Russel Apparels & Ekram Sweater Ltd (New Building)

Kathali, Bhaluka-2240, Mymensingh , Bangladesh
(24.380511, 90.377977)
14th November 2021

Observations

Data from provided soil test report

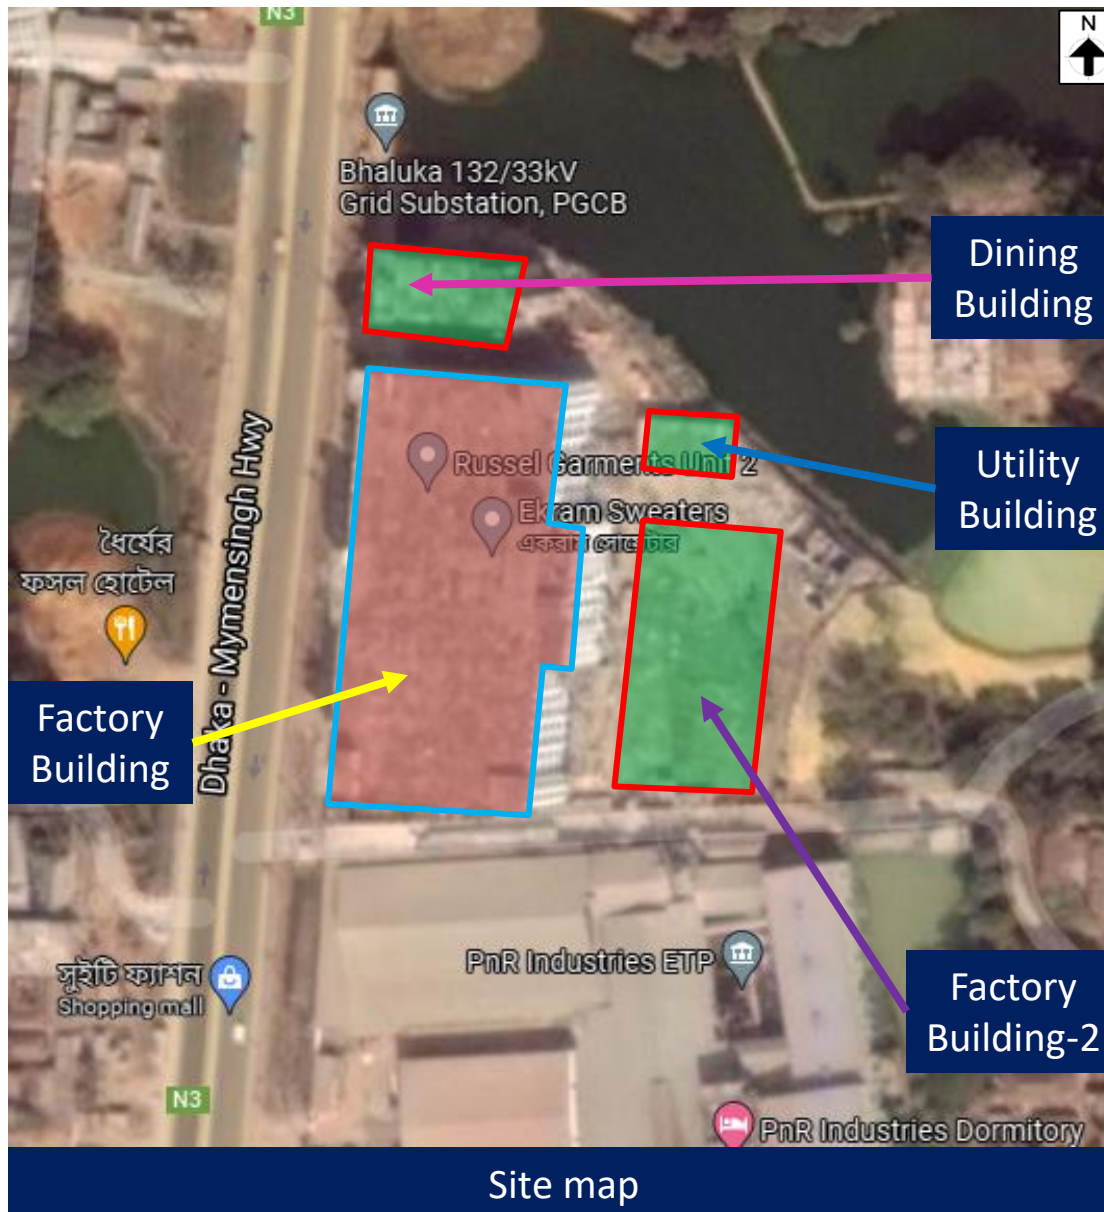
Foundation stressed above normal design limit

Cursory calculation indicates that bearing capacity of pile exceeds the normal design limit, considering 3 kPa live load on typical floors. Allowable capacity of pile has been considered 30 ton (FoS=2.5) at 15.25m depth from table of provided soil test report. Factory Engineer to review design, loads and foundation stresses.

Water ponding on roof

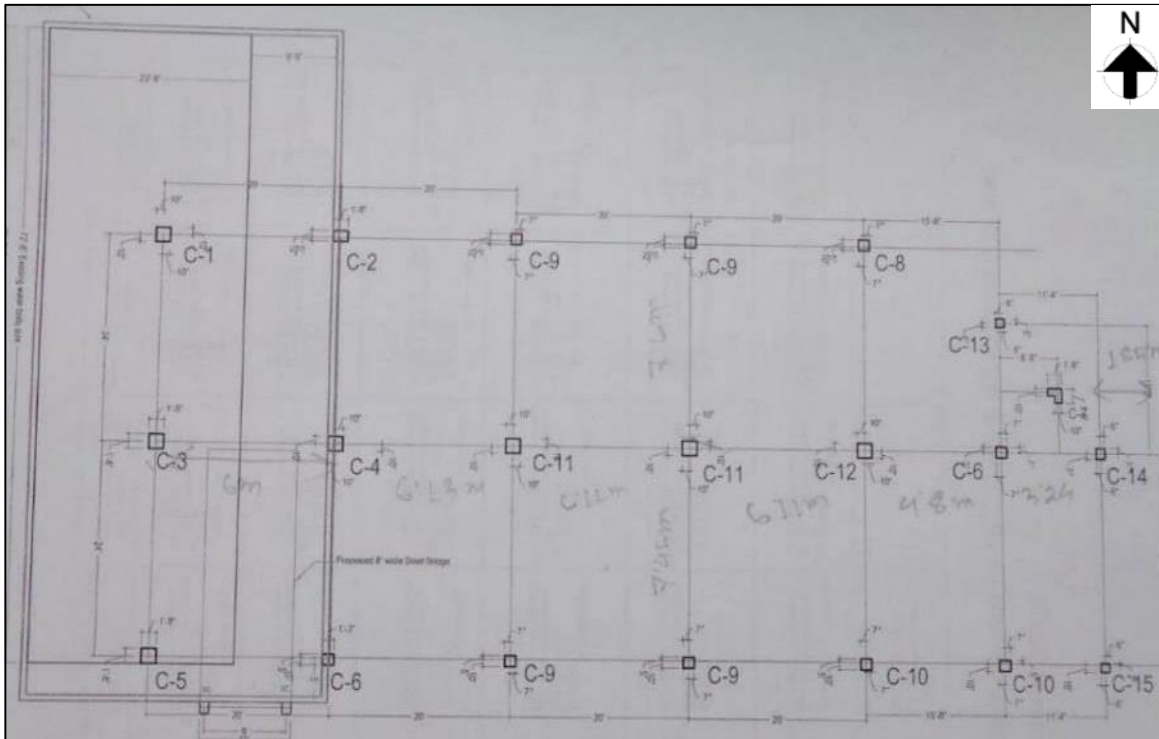
Water Ponding on roof

Factory is required to develop proper drainage system on roof with adequate slope or apply water proofing compound on roof slab to resist water ingress.

Water Ponding on roof

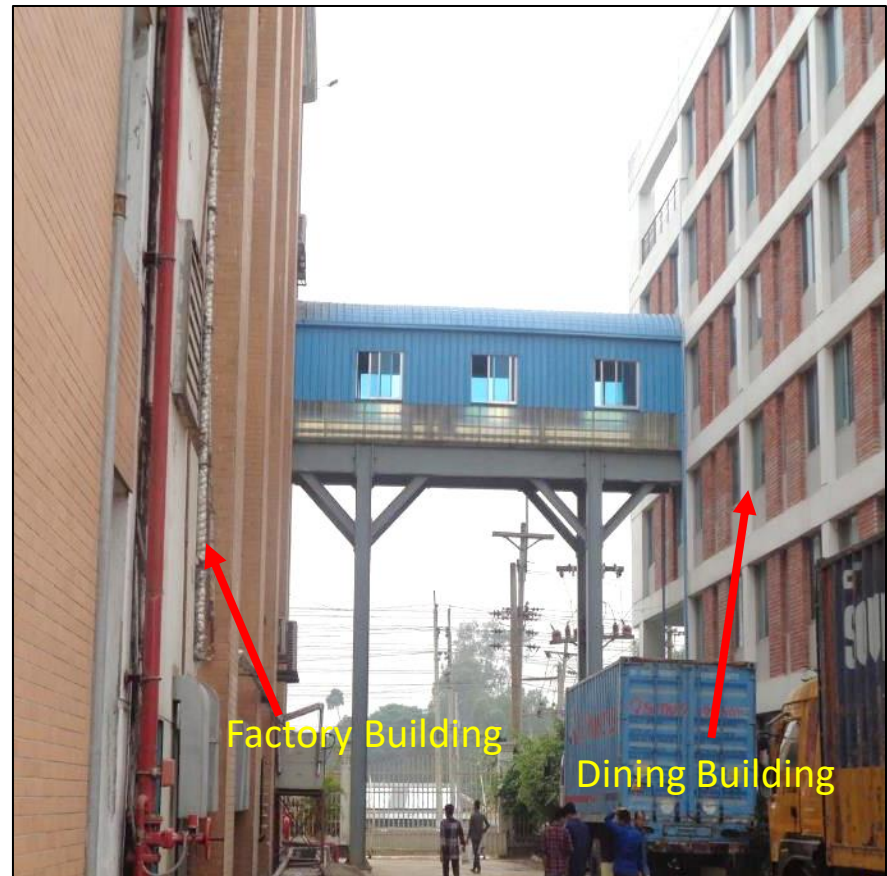
Water ponding on roof

Factory is required to develop proper drainage system on roof with adequate slope and apply water proofing compound on roof slab to resist water ingress.
